REF: GDC/MS/005/18-19/pk

ADDENDUM 1: CLARIFICATION

RE: TENDER FOR SUPPLY AND DELIVERY OF TOOL JOINT THREAD COMPOUND & DRILL PIPE TONG DIES- GDC/DO/OT/004/2018-2019.

Picture 1: Sketches showing dimensions in mm

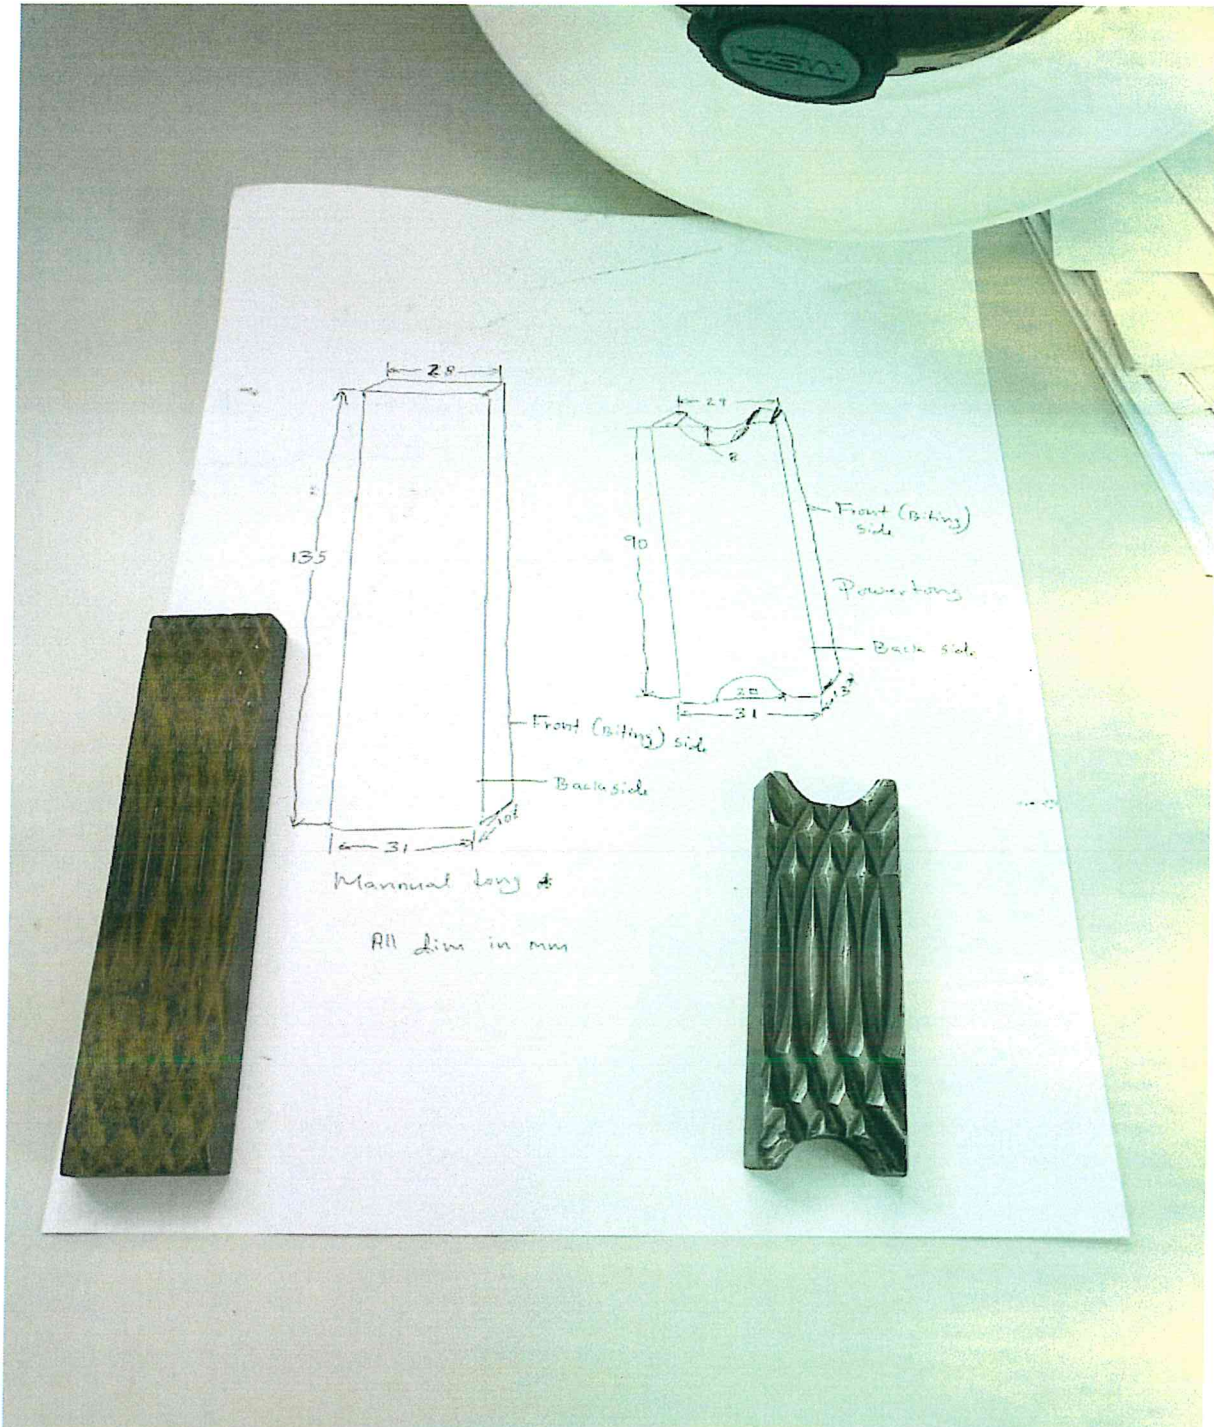
S.N	BIDDER'S QUESTION	GDC'S RESPONSE
1	GDC requires GRITFACE coating. Kindly clarify if this is a mandatory requirement or if a better solution can be offered?	Bidders are free to offer better quality of dies than what is specified in the tender document but should not fall below the indicated stipulated specifications. GDC emphasizes on the best quality.
2	<p>1. Would the client provide part numbers for Drill Pipe Power Tong Dies and Drill Pipe Manual Tong Dies?</p> <p>2. Drill Pipe Power Tong Dies for ZQ203-100 Applicable Pipe OD: 3½" - 5½"</p> <p><u>Please Clarify</u> Which size would best suit your application? Option 1: -7/16" (length) x 1-1/4" x 3-1/16" Option 2: -1-3/16"(Length) x 1-1/4" x 3-1/2" Option 3 : -1" Length) x 1-1/4" x 3-1/2"</p>	There is no standard part number for the dies as different manufactures have different part numbers for the same. Sketches and photos showing dimensions are as shown in subsequent pages.
